**RESOLUTION AUTHORIZING CONTRACT MODIFICATION #02
FOR THE PURAC PHASE III PROJECT**

Subject: North Hudson Sewerage Authority
Project No. S340635-30
PURAC System Improvements Phase 3 – Physical System Improvements
Contract Modification No. P-02

No. P-02:

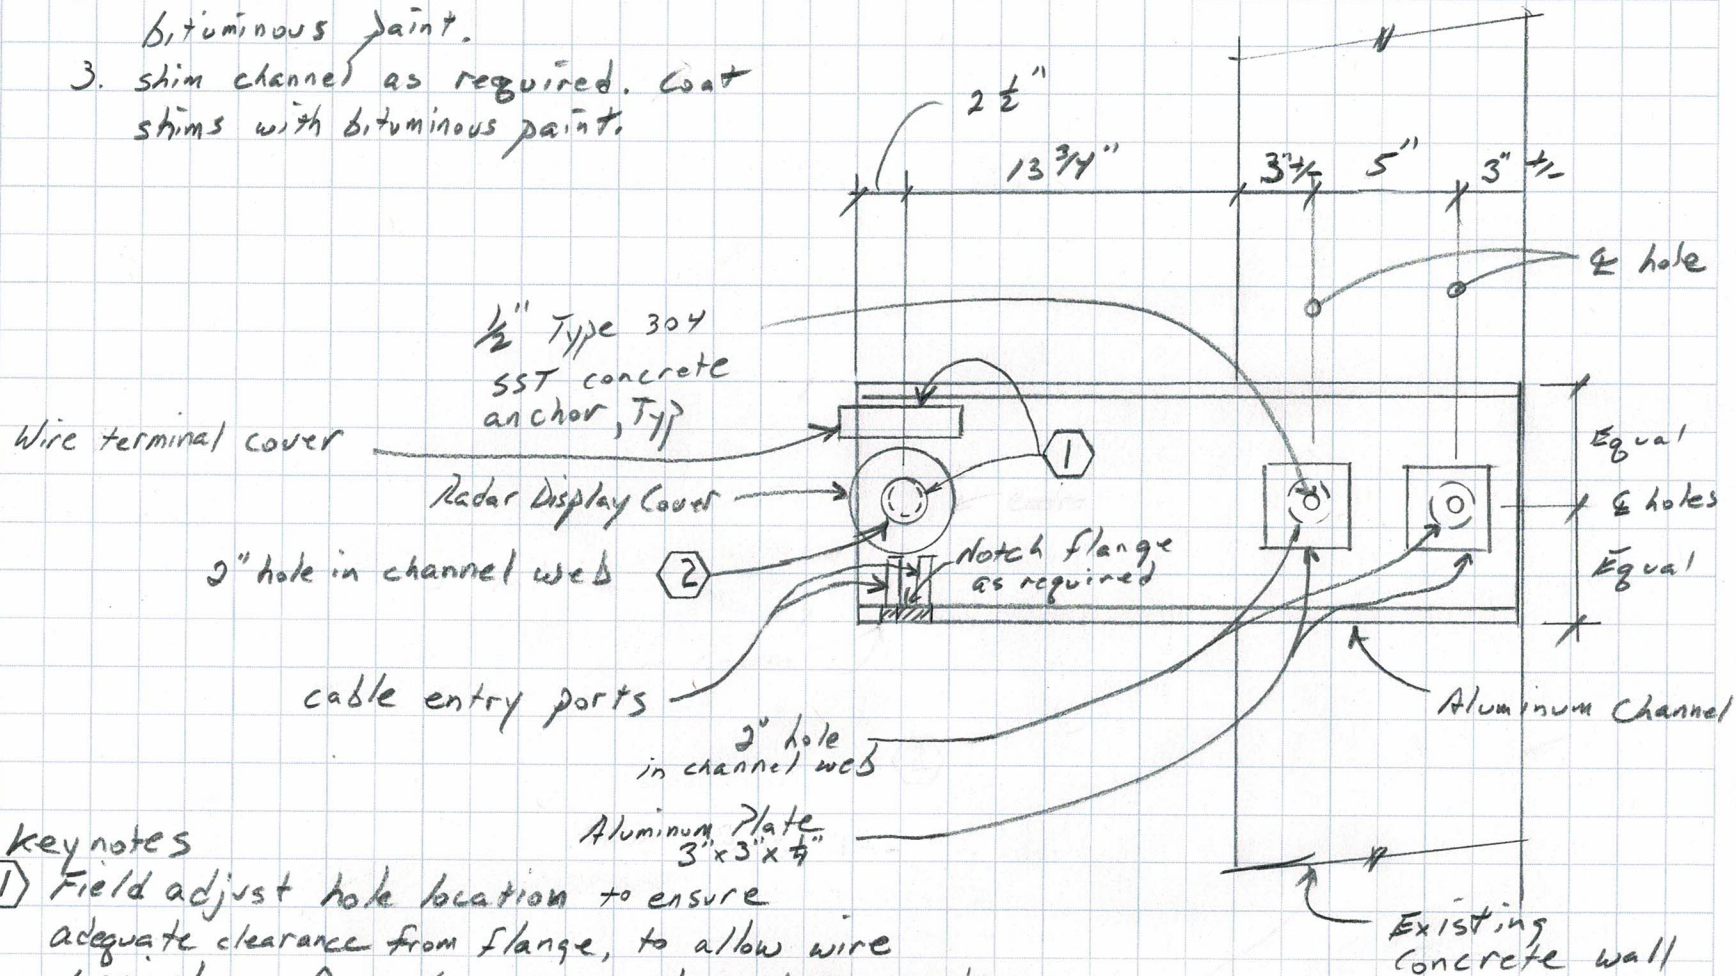
- 3. Furnish and install Qty. 10: custom mounting brackets. Refer to attached Jacobs bracket design sketch and level transmitter dimensional drawings.
- 4. Provide manufacturer's representative's field startup, testing, and training for the new level instruments. Estimate the startup of 10 level instruments with be concurrent with training of plant operations and maintenance staff. Estimate (2.5) 10-hour days. Refer to attached manufacturer's representative's quotation. Provide shop drawing submittals for Engineer's review and approval, prior to purchase or manufacture.

1. Aluminum Channel shall be C10 x 5.28, or equal. Flat side down, flanges up.
2. Coat aluminum surface in contact with concrete with bituminous paint.
3. Shim channel as required. Coat shims with bituminous paint.

- ① Field adjust hole location to ensure adequate clearance from flange, to allow wire terminal cover to be unscrewed and removed.
- ② Install 2" Myers hub in hole. Install 1.5" NPT radar stem into female end of Myers hub with reducer bushing. Field verify connection sizes and provide fittings as needed.

RFI NO: 049

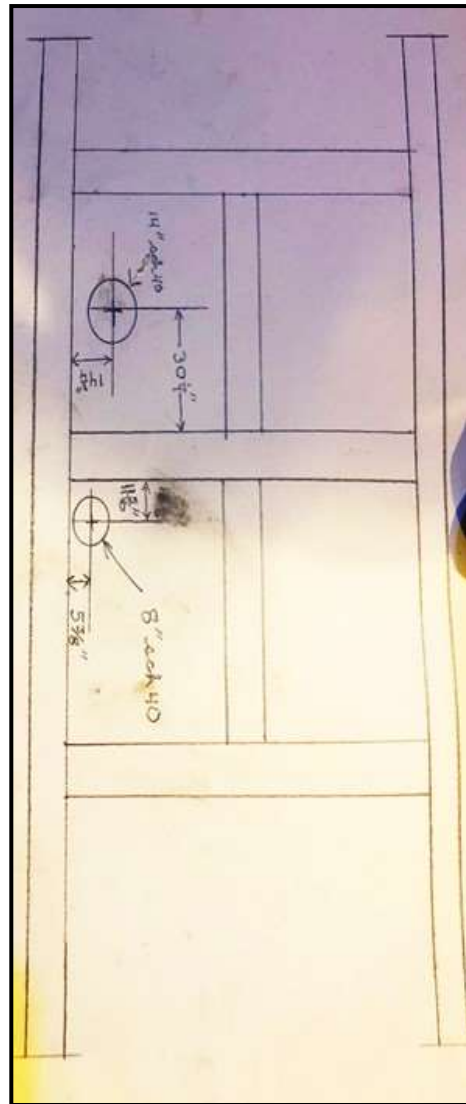
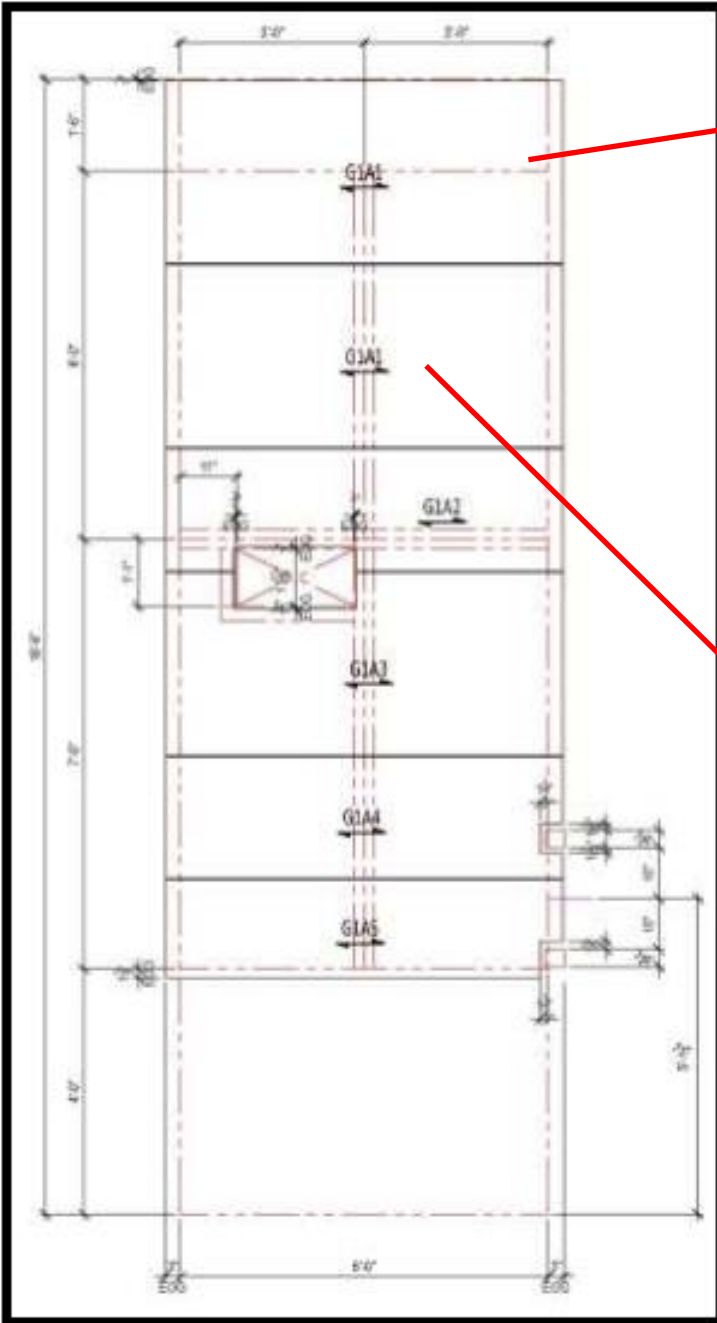
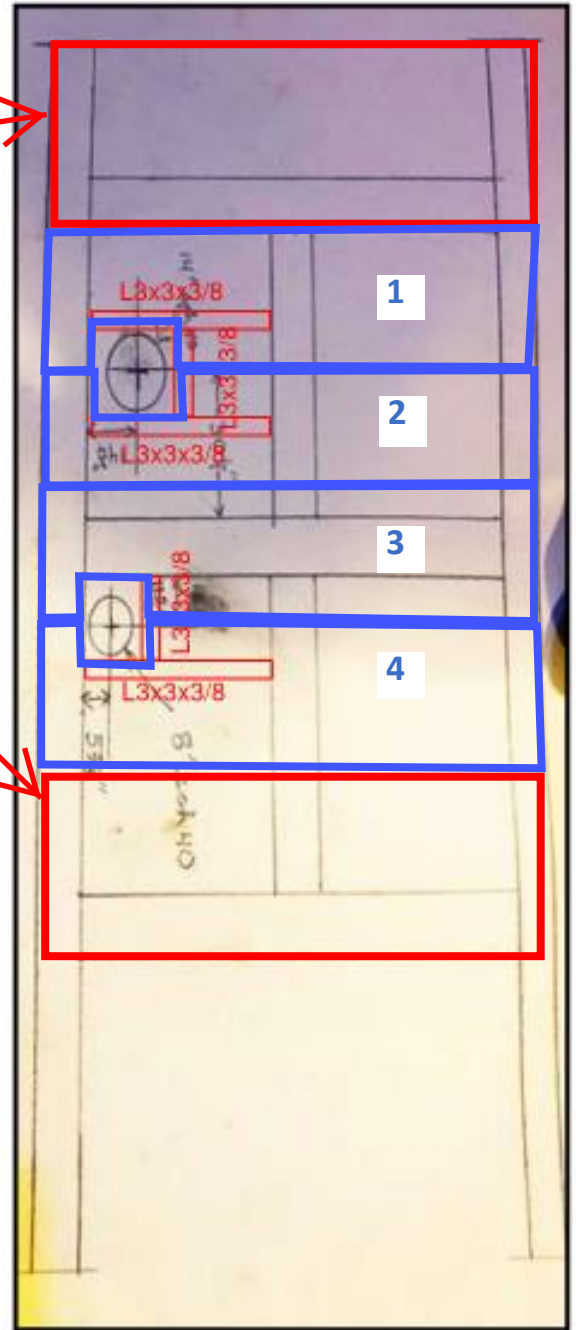
- New Grating Panels - per updated platform layout RFI 049
- New Framing steel angles (4) x L3x3x3/8 – per attached New Layout
- Ladder extension and mods – per attached ladder modification detail

The access platform was required in Cell 6 however in the design was placed in Cell 5. The design has been modified for Cell 5 which resulted in a redesign of the platform grating and ladder to accommodate the existing vertical pipe in the area.

Drawing Number: 300-WWTP-M-2

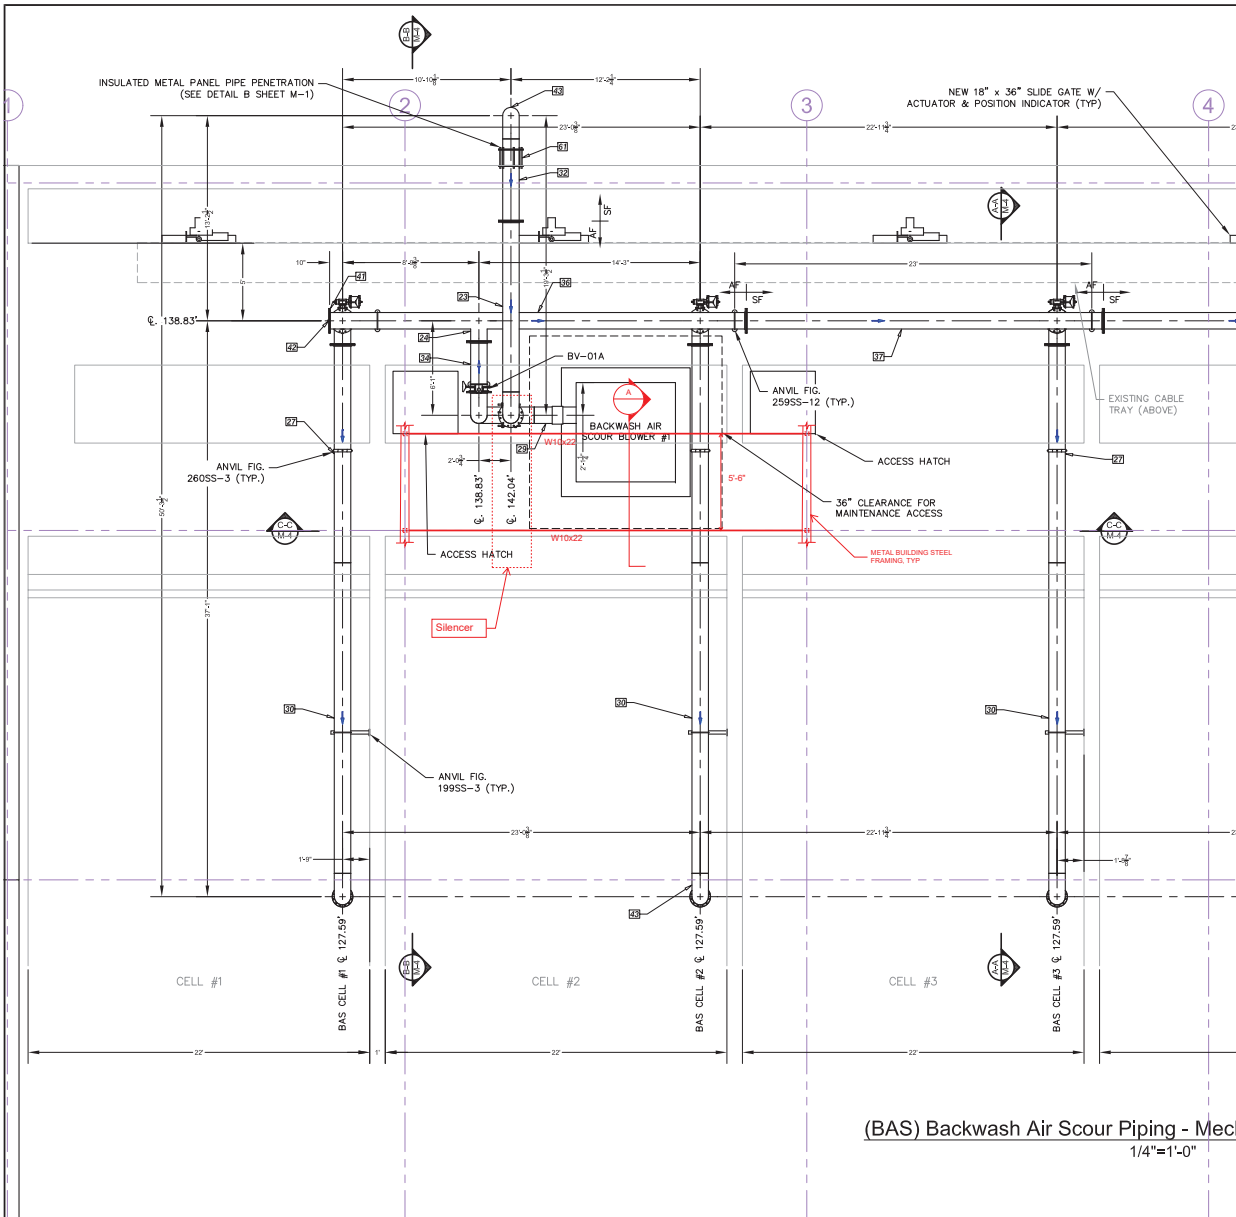
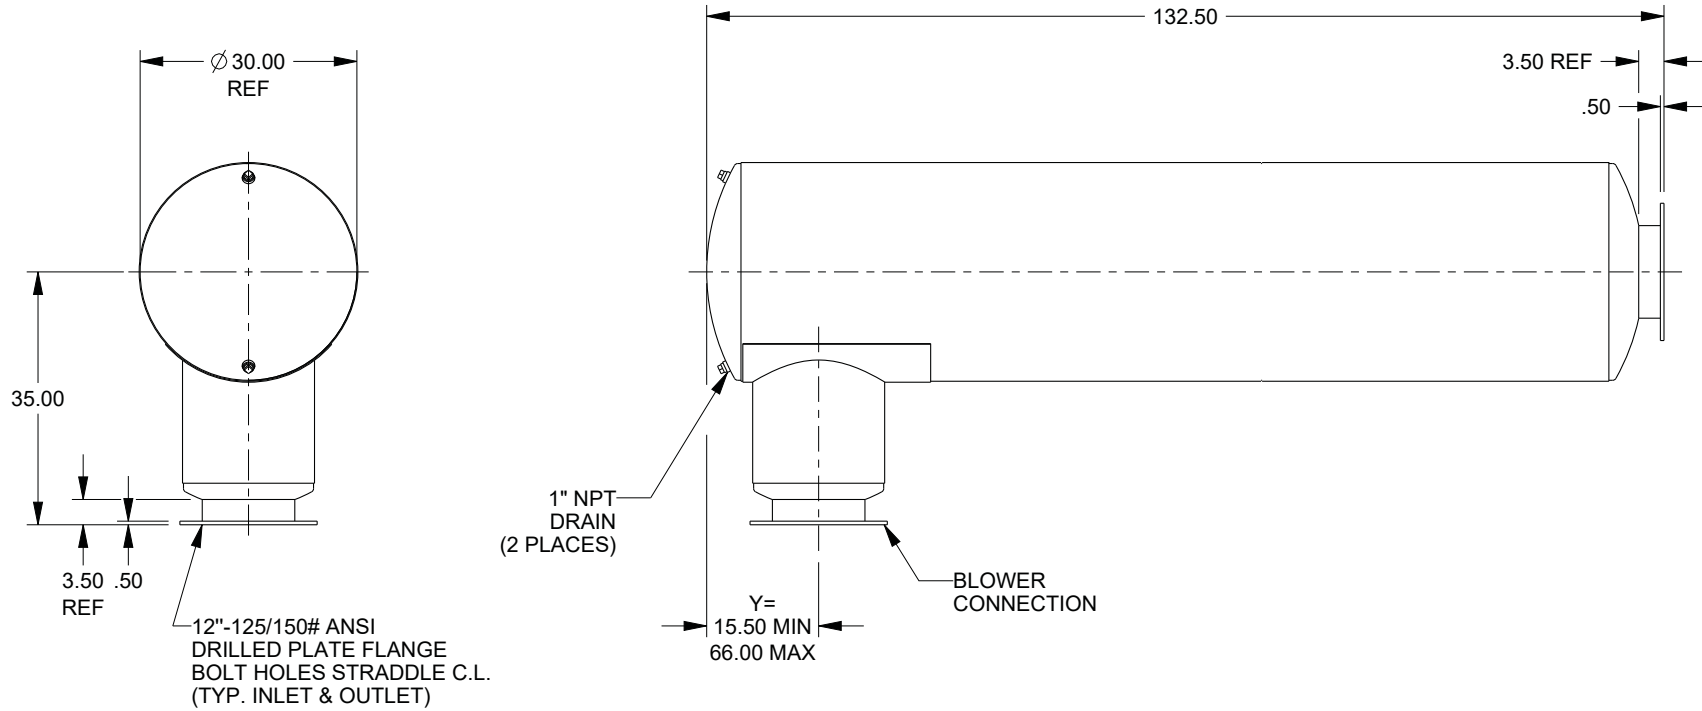
Furnish and Install 2 Durr Universal Inlet Silencers Model Special RDY-12 (Inlet, CS EPA AIS) for the blowers. See attached communication with the manufacturer for material details and drawing for installation details.
